PLAN AND ZONING COMMISSION MEETING

CITY OF DAVENPORT, IOWA

Case F21-08: Request of S.J. Russell, L.C. on behalf of Sophie Foster Revocable Trust for a Final Plat of Birchwood South First Addition for a 6-lot subdivision on 17.92 acres located at 4607 East 53rd Street. [Ward 6]

Re: PRJ-2511

BIRCHWOOD SOUTH FIRST ADDITION

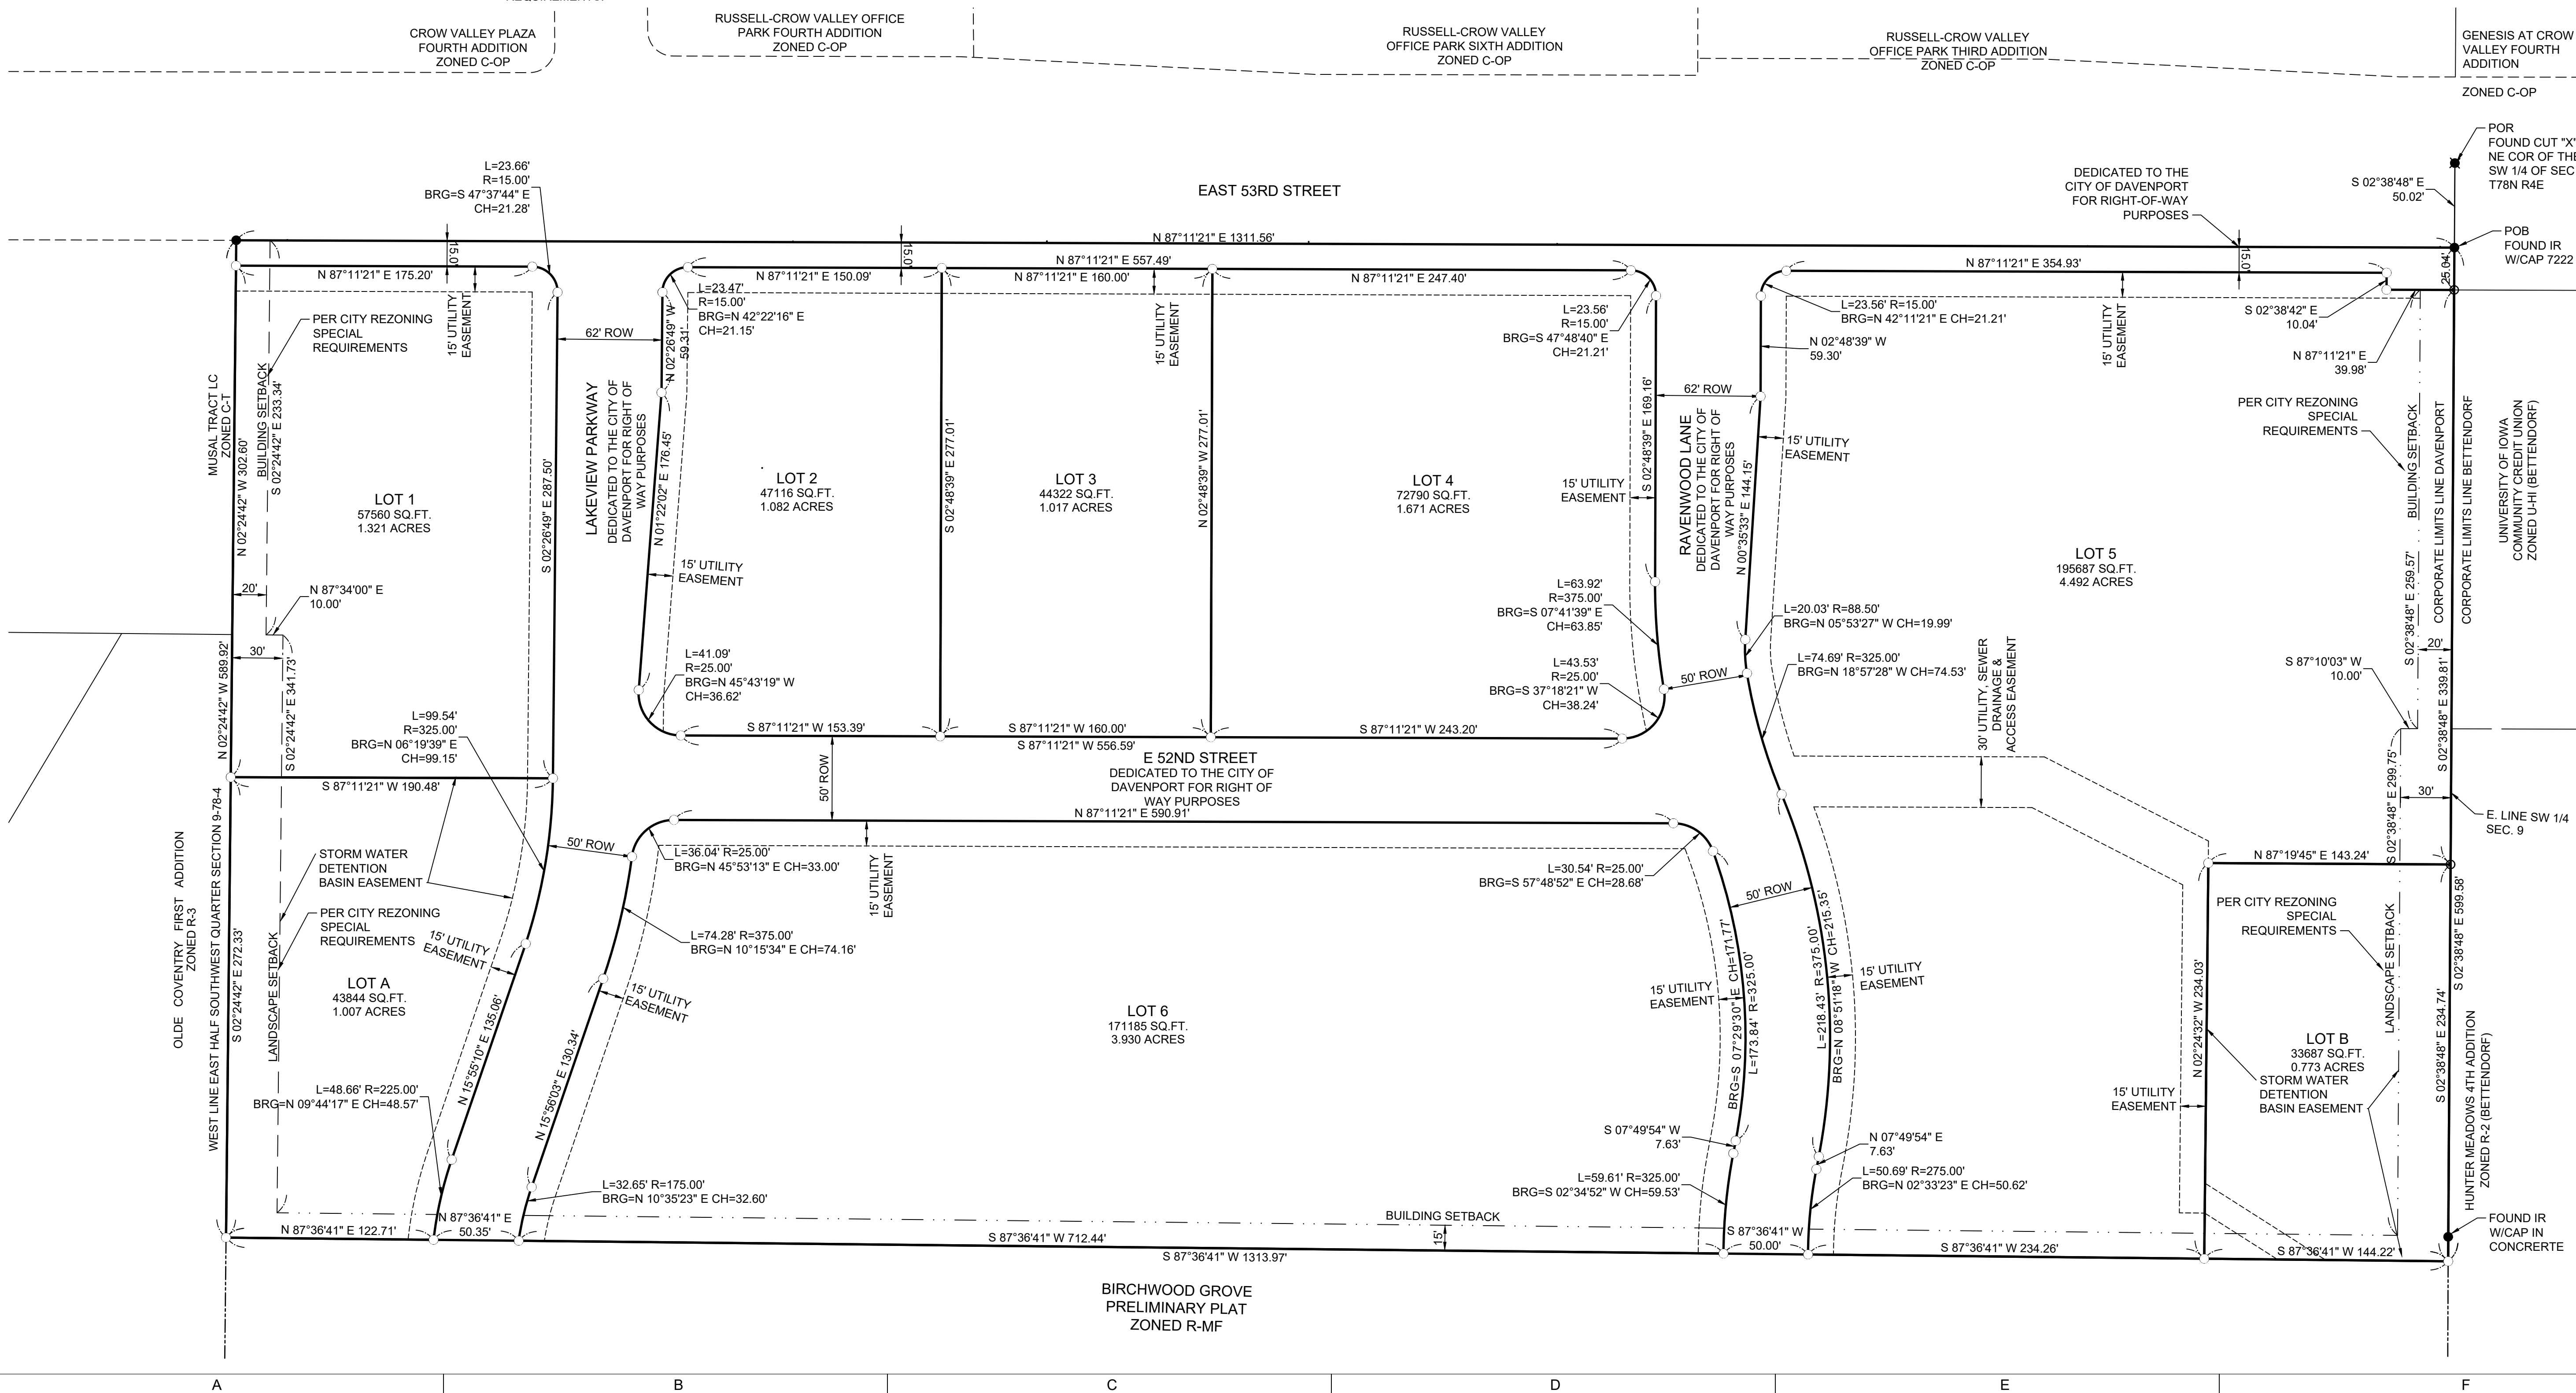
Remove 'Zoning' note #2 and #3.

Under the 'Zoning' notes, list the following rezoning conditions from Ordinance 2021-105:

The 15' easement that runs on the north should contain the word "sewer" in the description.

All easements that contain public sewers should include in the description, "sewer". Even though they're in the ROW, update the easement on the south of E 52nd to include "sewer" in the description.

All curves also need the central angle shown.

Add Metro Link signature block.

Add a 15' utility easement on the north side of 52nd Street.

Add Metronet as a utility signatory.

SURVEY TYPE: FINAL PLAT						
FILE	BOOK	SCALE	DRN	CHK'D	DATE	JOB NO.
DAVENPORT	#8630	1"=60'	TJB	MWK	7/21/21	8630.21
REV.		8630 FINAL PLAT DWG			SHEET	OF

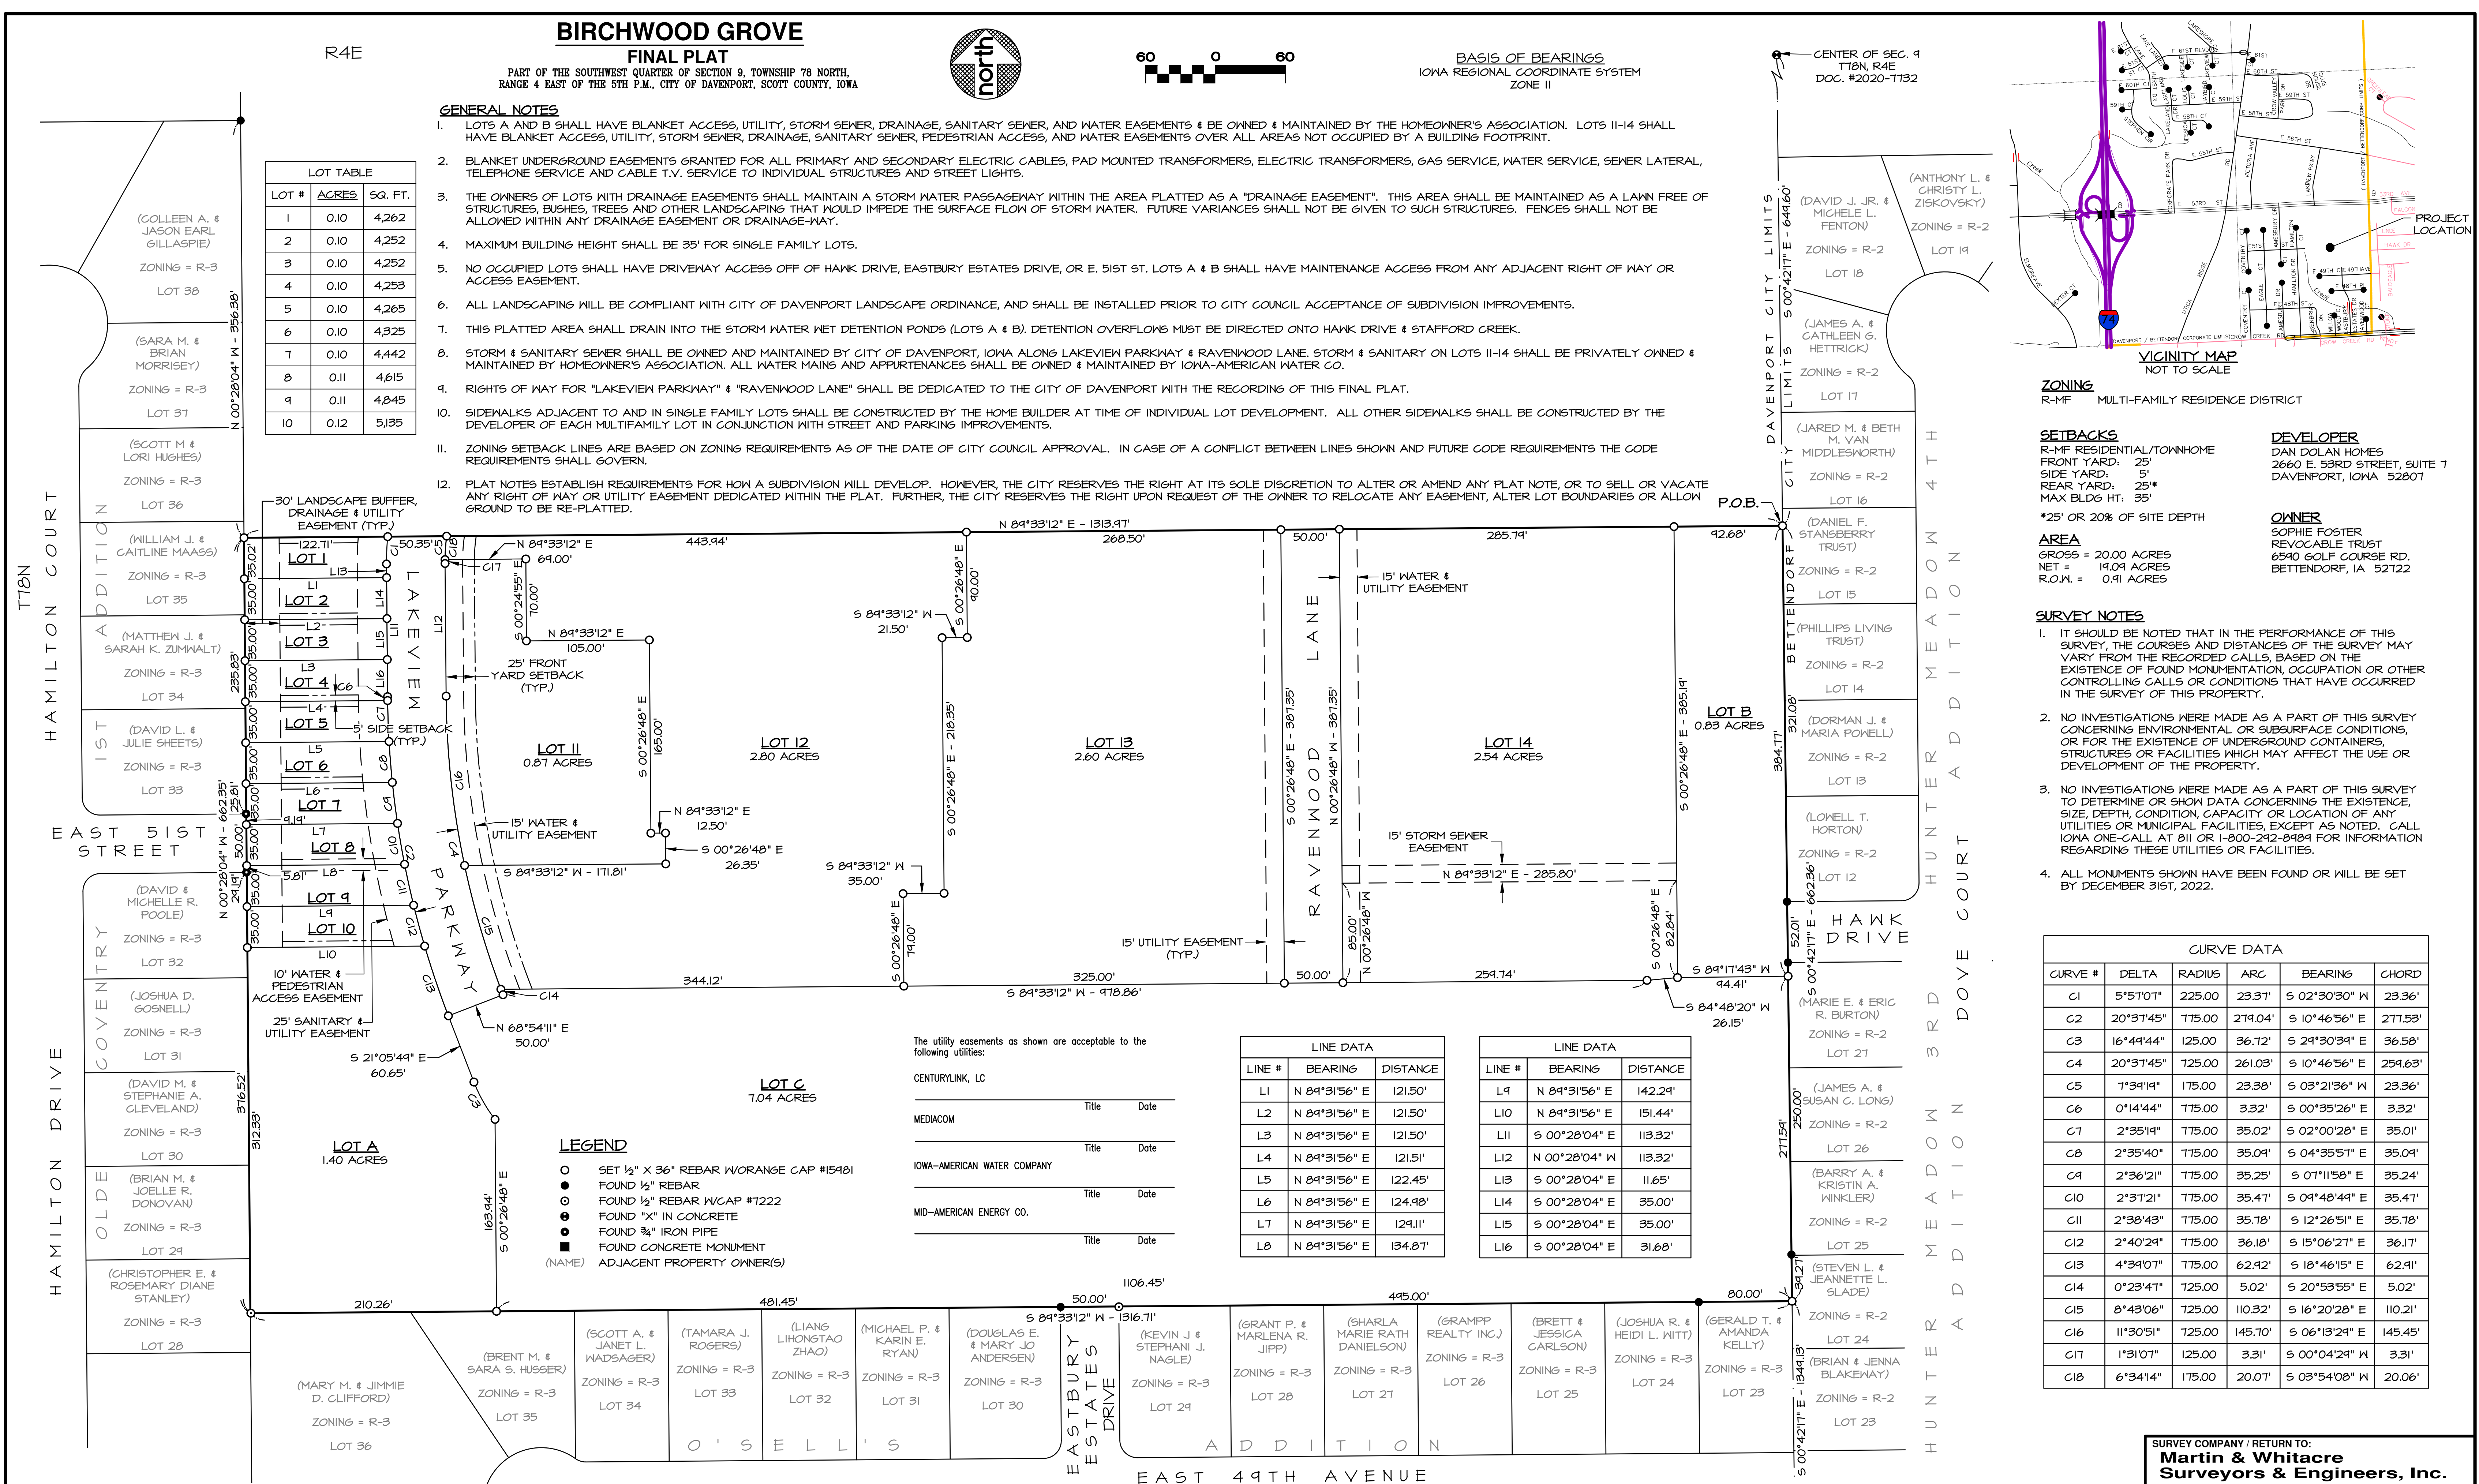
Include a note stating, "The 30' landscape buffer shall be planted prior to the issuance of any certificates of occupancy."

Revise Note #4 to state, "The height of structures in the R-MF zoning district shall be no greater than 35 feet."

Add a note stating, "Upon vacation by the City of a portion of Eastbury Estates, Petitioners, jointly and severally, shall be responsible for paying for or executing the work specified by the City of Davenport for reconfiguring/redesigning/reconstructing the northern terminus of Eastbury Estates in the area abutting the southern boundary of the subject property. The City is to provide plans, including a site plan and landscaping plan to Petitioners."

General Note 10: Add to the last line, "or so order by the City of Davenport."

The proposed sanitary sewer, "SA12" from the plans, at the south of lot B there will need to be at least 7.5' from the sewer to the property line or an additional easement will need added to lot C. The other option would be to move SA12 slightly north.

Remove Survey Notes Nos. 2 and 3.

The "Land Description" is not needed on the plat, removal would provide less clutter.
